SEWAGE DISPOSAL SYSTEM

MARYLAND STATE DEPARTMENT OF HEALTH

SUBDIVISION (Ilchester Farms) ROAD 4751 Ilchester Road LOT 9

PERMIT CARD

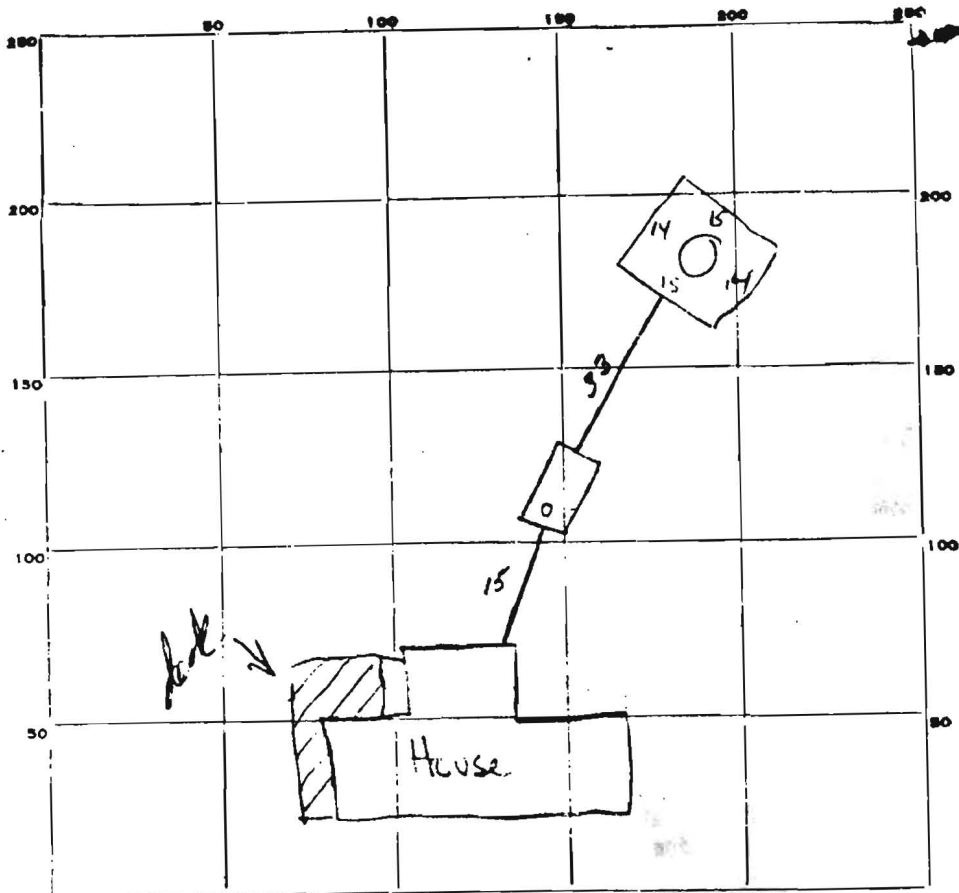
2 Aug '78 - Slope of house sewer too great; 1 3/4" drop per foot. Slope must be changed. OK to bracket from inlet tank to cleanout. Call when slope is corrected (CLR)
